1ST AND PIKE

DESIGN REVIEW BOARD | FEBRUARY 12 2019 | DPD #3028428

Aerial View of Roof Terrace

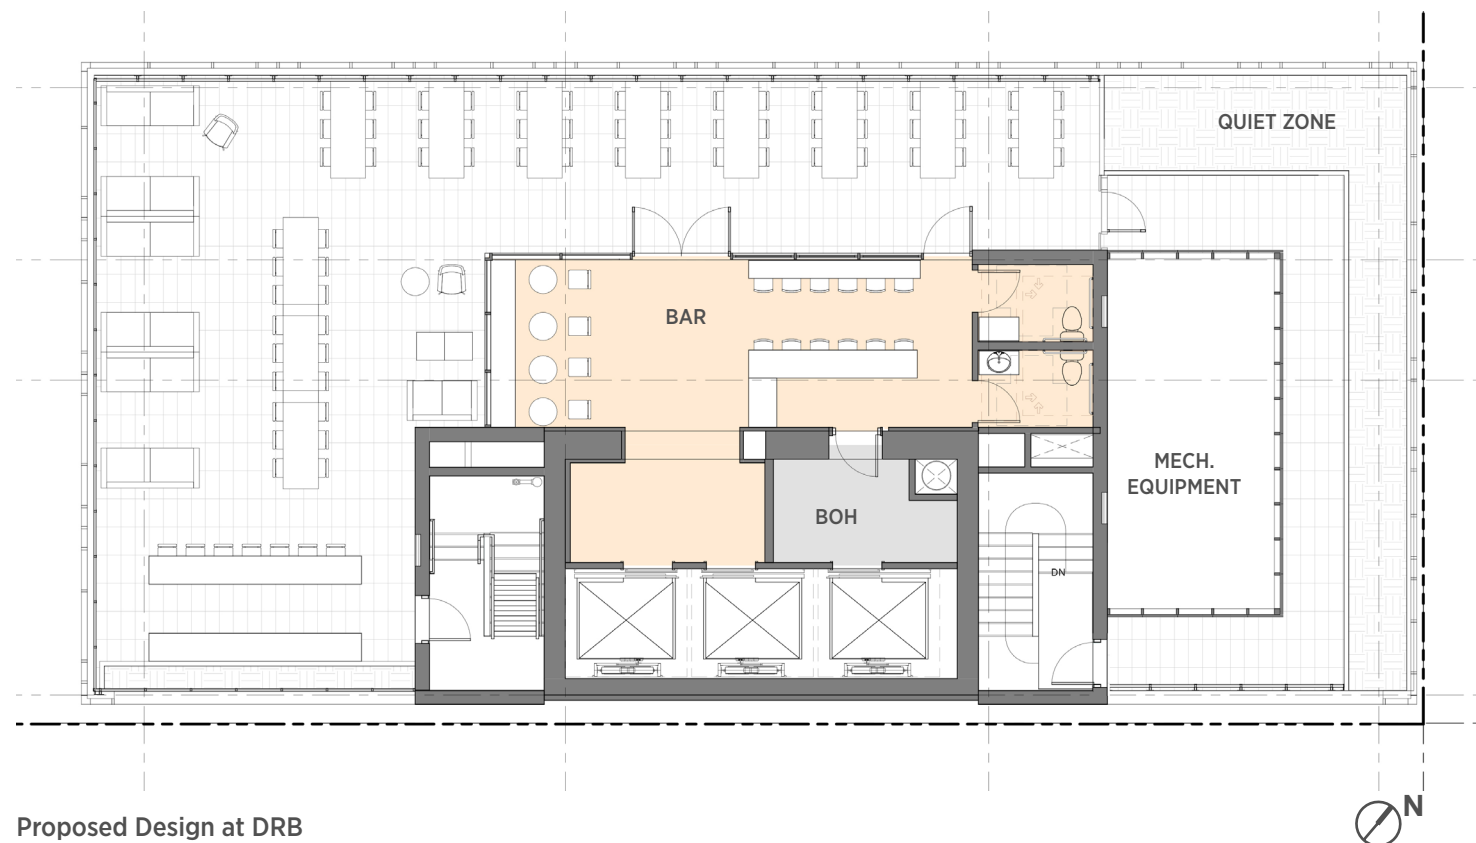
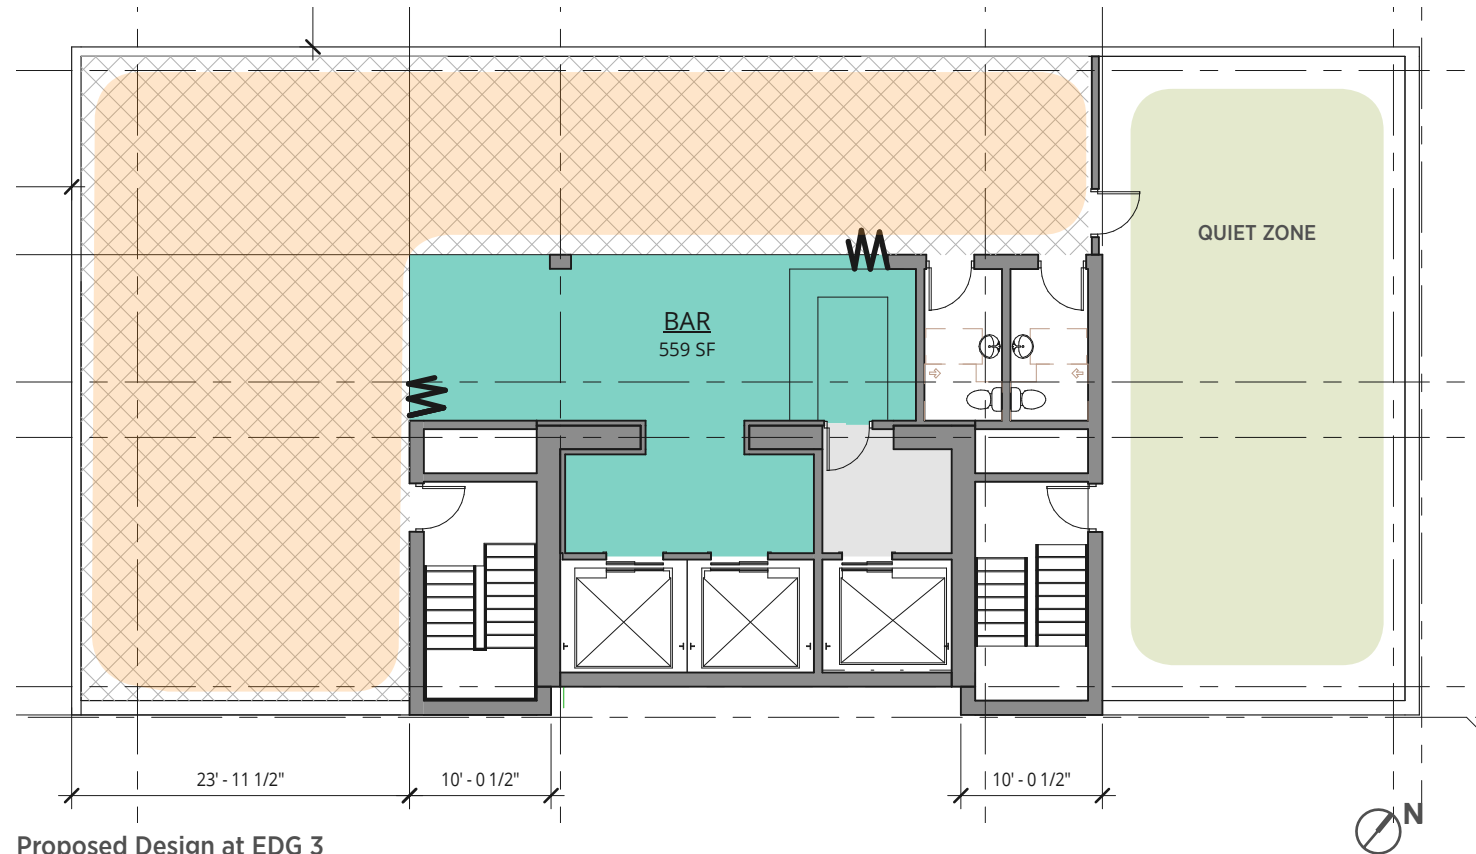
“The Board reviewed the revised roof amenity concept design, appreciated the simplification of the roof terrace structure and commented that it had been well designed as ‘fifth facade.’ At the recommendation meeting, the Board requested the design team provide a rendering of the roof as it will be viewed from the Newmark Tower.”

As the roof has evolved with technical requirements, the design team has worked to ensure the roof terrace design is simple, compact, and respectful to the neighbors to the East. The activity of the roof terrace is focused to the West; planting and screened mechanical are on the East.
